RIDGWAY PLANNING COMMISSION

SPECIAL MEETING AGENDA

1. **Application:** Sketch Plan; **Location:** McChesney Minor Subdivision, Lot 2; **Zone:** Residential (R) and Future Development (FD); **Applicant:** Chris Hawkins dba Alpine Planning, LLC; **Owner:** Four Winds Ranch, LLLP & Estate of Bernadine C. Endicott

To: Town of Ridgway Planning Commission
Cc: Preston Neill, *Ridgway Town Manager*
From: TJ Dlubac, AICP, *Community Planning Strategies, Contracted Town Planner*
Date: March 31, 2023
Subject: Four Winds Sketch Plan for April 4th PC Meeting

Figure 1. Zoning Map

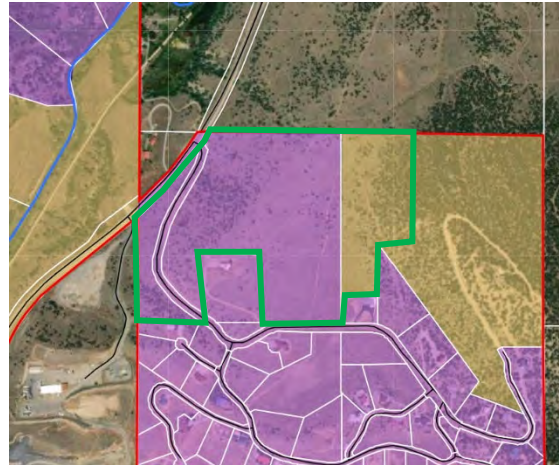
Currently, Lot 2 is zoned Residential, and the Endicott Property is zoned Future Development. The Applicant will need to request a rezoning of the Endicott Property pursuant to RMC §7-3-22 and RMC §7-3-23.

Figure 4. Steep Slopes

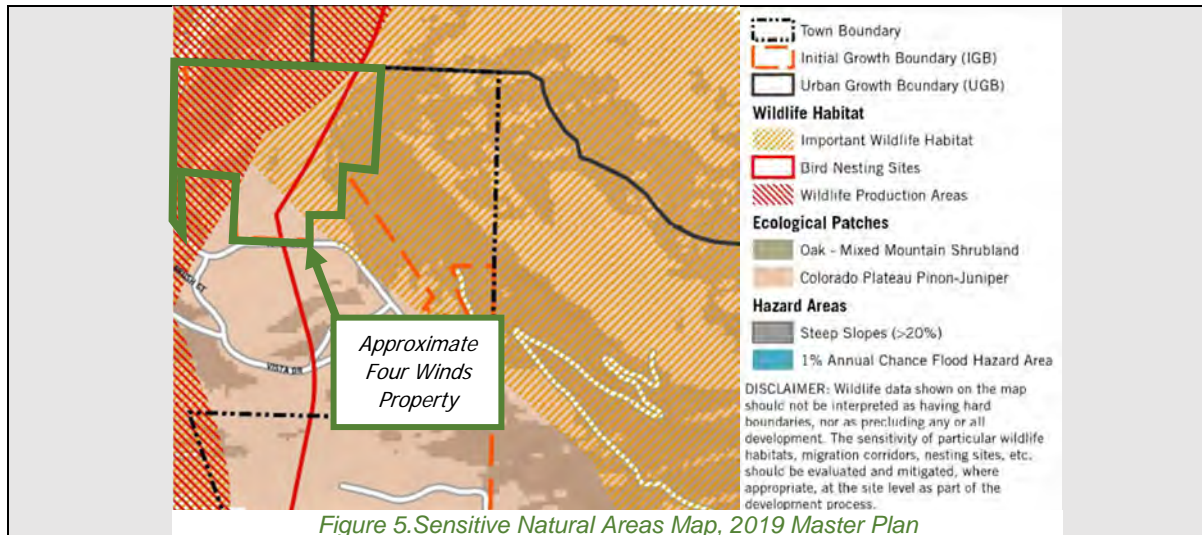
The Applicant has suggested in the response letter that steep slopes are generally 30% or greater. While this is the generally accepted slope, the 2019 Master Plan specifically identifies slopes of 20% or greater as "environmentally sensitive areas" and Policy ENV-1.1: Environmentally Sensitive Areas states "Limit new development in environmentally sensitive or constrained areas...". The Application impacts environmentally sensitive areas as indicated in the 2019 Master Plan. Below is a snip of the Sensitive Natural Areas map which identifies the Property as being impacted by these environmentally sensitive areas.

Since the proposed lot lines are not depicted on this map nor are these areas overlaid with the proposed subdivision, Staff is unable to fully understand the impact the Application will have on environmentally sensitive areas and would request that the Applicant provide the Town with a map identifying the environmentally sensitive areas identified in the 2019 Master Plan overlaid on the proposed subdivision layout for review.

Figure 6. Alternative Sanitary Sewer Alignment

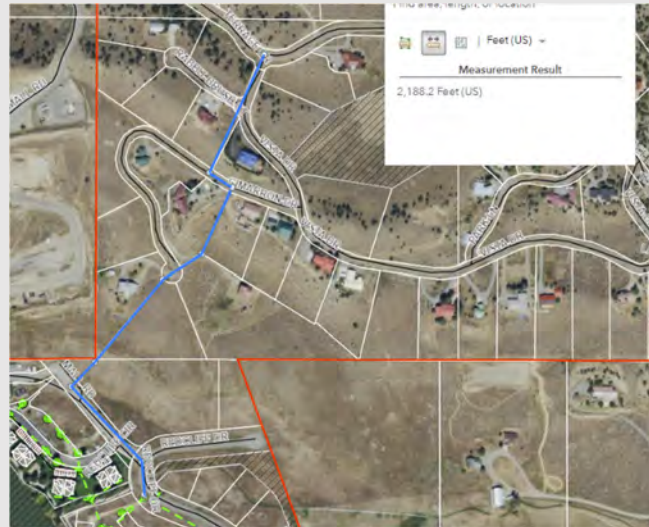
Another potential alignment has been identified by extending the existing sewer lines from Mall Road up the hillside and running within the 10' utility easements that straddle each lot in Vista Terrace (see image to the right). The Applicant implied that there were regulations in place that would prohibit the ability to utilize these platted easements for the extension of sewer lines. Documentation to this effect has not been provided to Staff as of the drafting of the staff report. Upon evaluation of the plat notes for Vista Terrace Sub. Filing No. One, there aren't notes that further limit the specific use of the platted utility easements.

Additional evaluation to better understand this alignment should be provided. Again, the concern here is that if connecting this project to sanitary sewer is in fact financially infeasible, the costs of all alternatives need to be fully understood prior to the Town fully supporting a waiver of public health, safety, and welfare standards.

PROJECT	2022-018-CIV
DATE	03/13/2023
DRAFTER	WL
CHECKED	DCQ
BUCKHORN ENGINEERING	
SHEET	
SP-5	
SHEET 5 OF 10

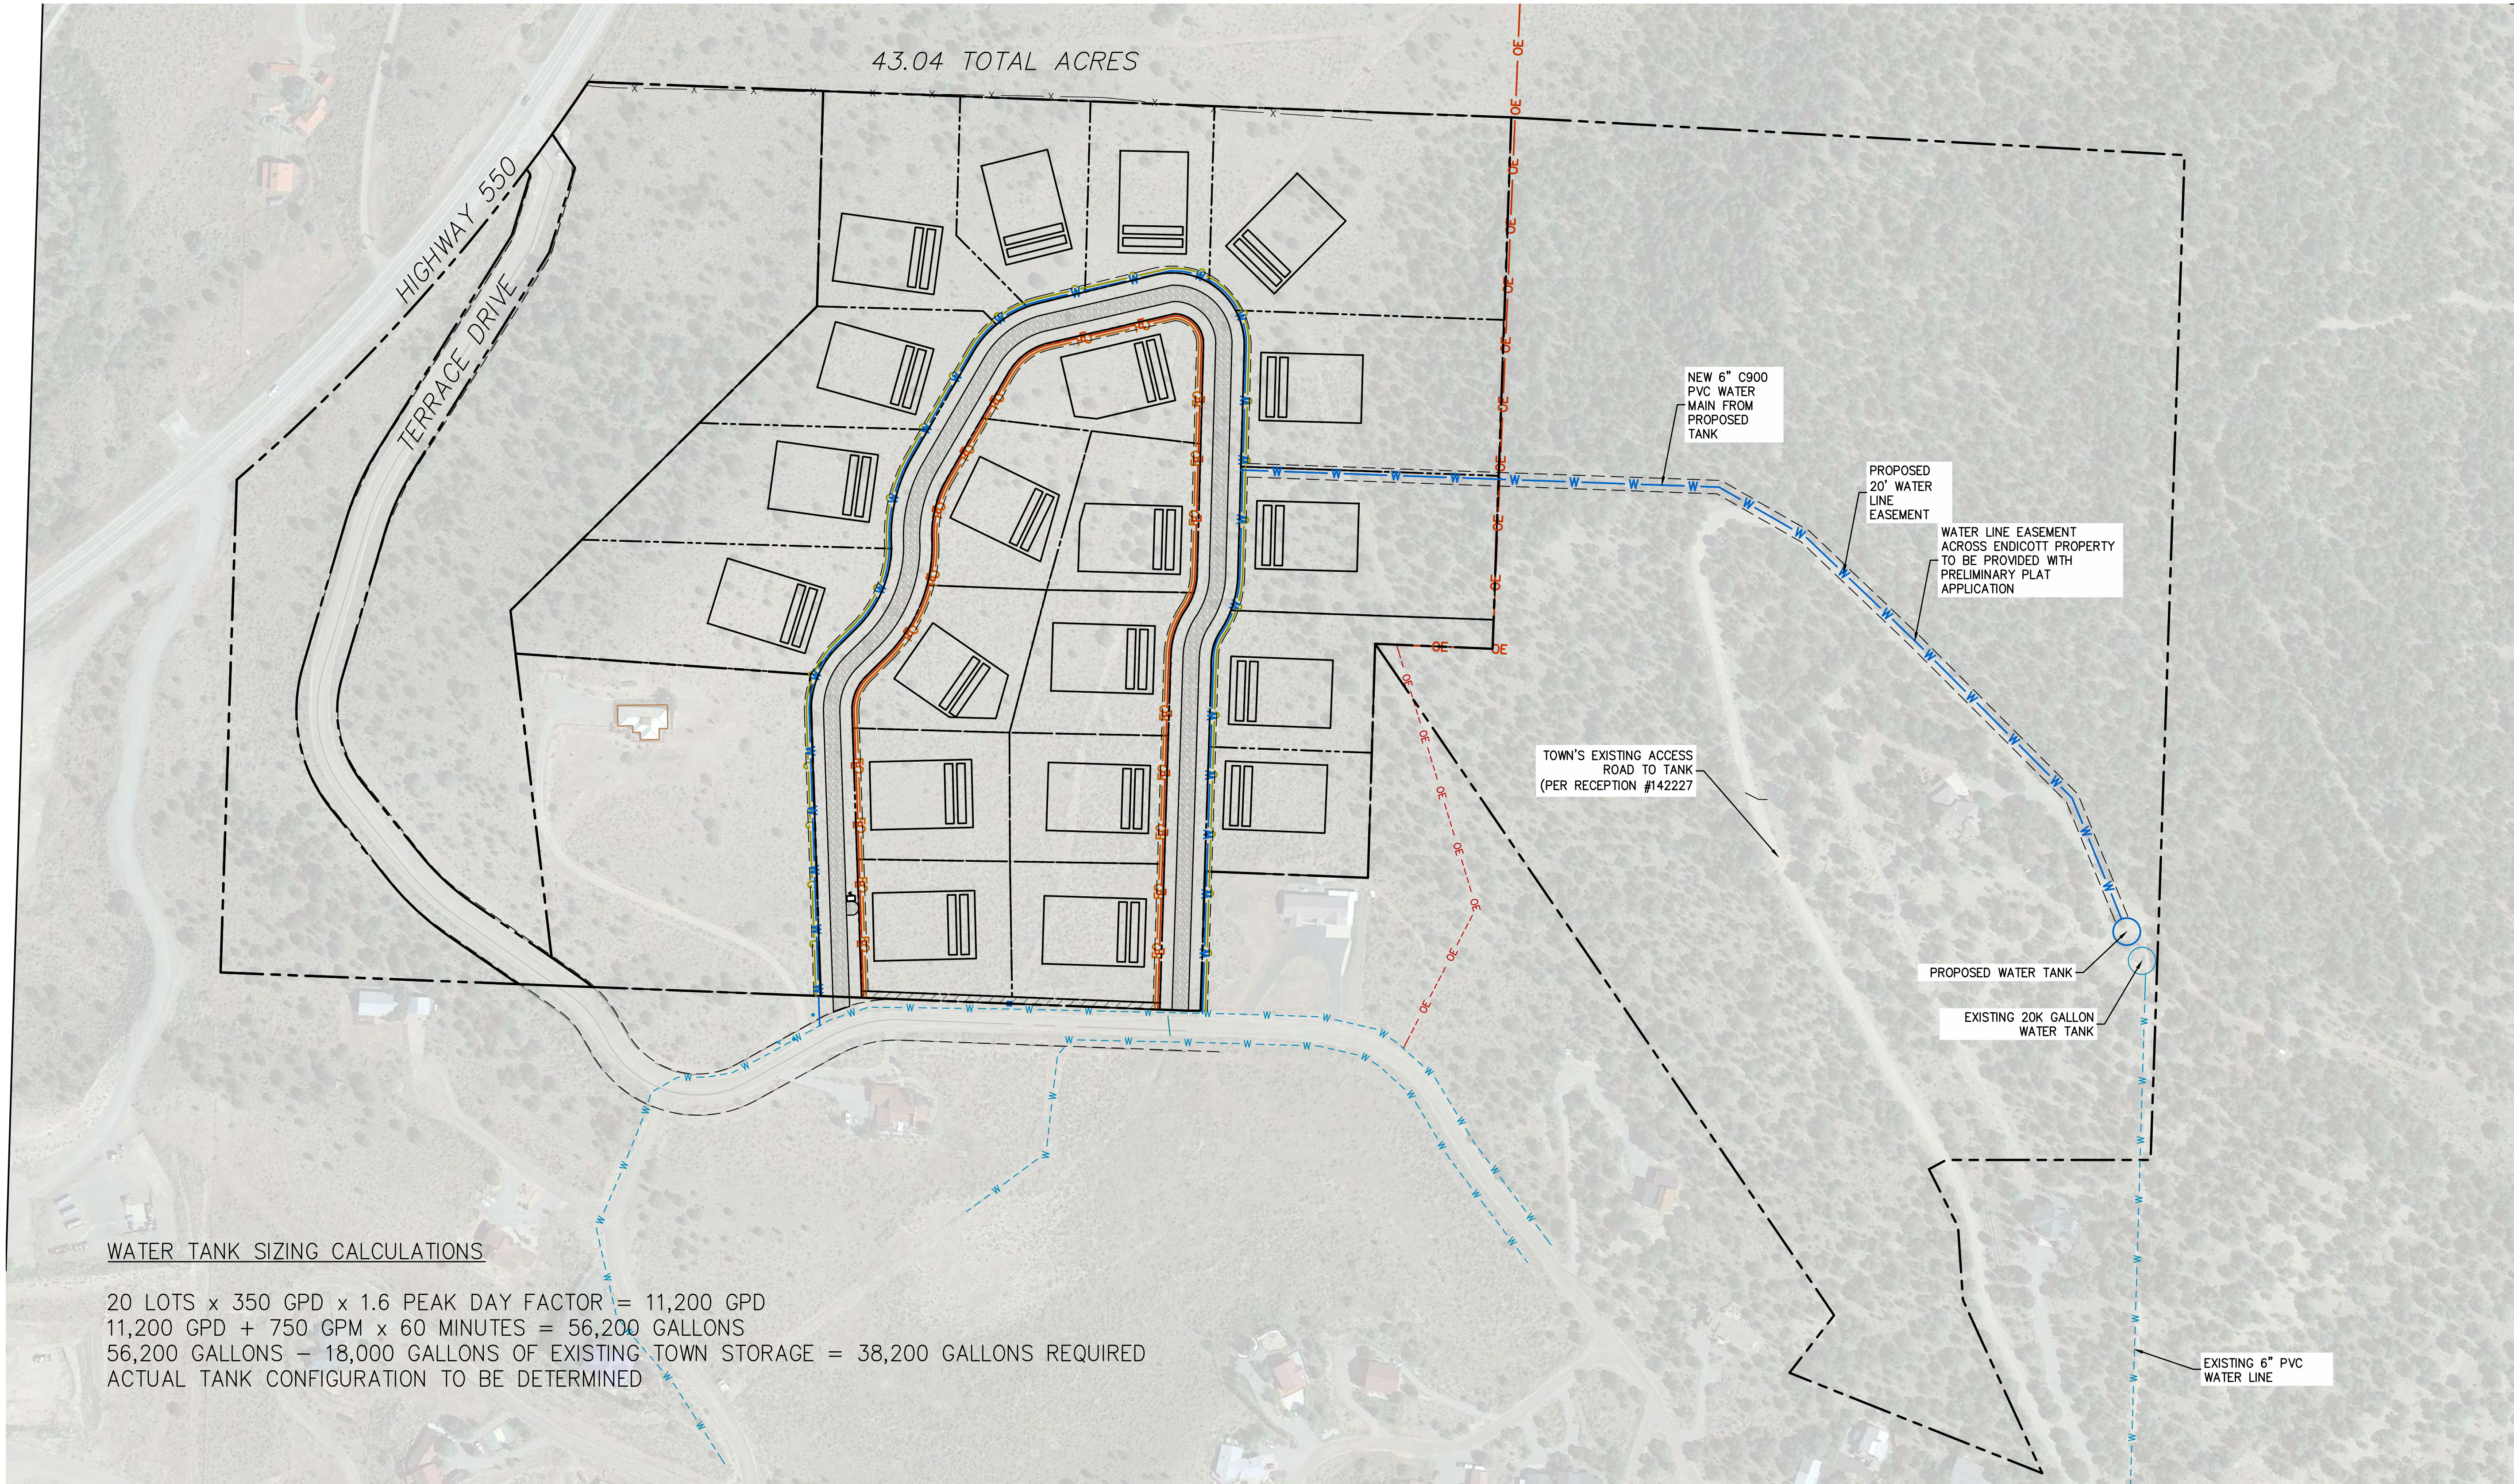
4. Consider requiring wildlife-friendly trash enclosures and measures to reduce conflicts between wildlife and residents. Address this item further with the submittal of the preliminary plat. *Agreed. Please see Note 4 on Sheet SP-5.*

7. Add Note 1 from McChesney Minor Subdivision regarding Sewage Disposal to the Preliminary Plat. *Already added. Please see Note 5 on Sheet SP-5.*
8. Add Note 3 from McChesney Minor Subdivision regarding costs of improvements to the access to HWY 550 to the Preliminary Plat. *Already added. Please see Note 6 on Sheet SP-5.*

25. Pg 2: Very little of Lots 7, 10 and 14 are shown within the 300 ft radius of a fire hydrant. This hydrant layout is a bit different from the original sketch plan. Is this revised version the correct version? A new hydrant was added to capture Lot 14. Please refer to Sheet SP-5.
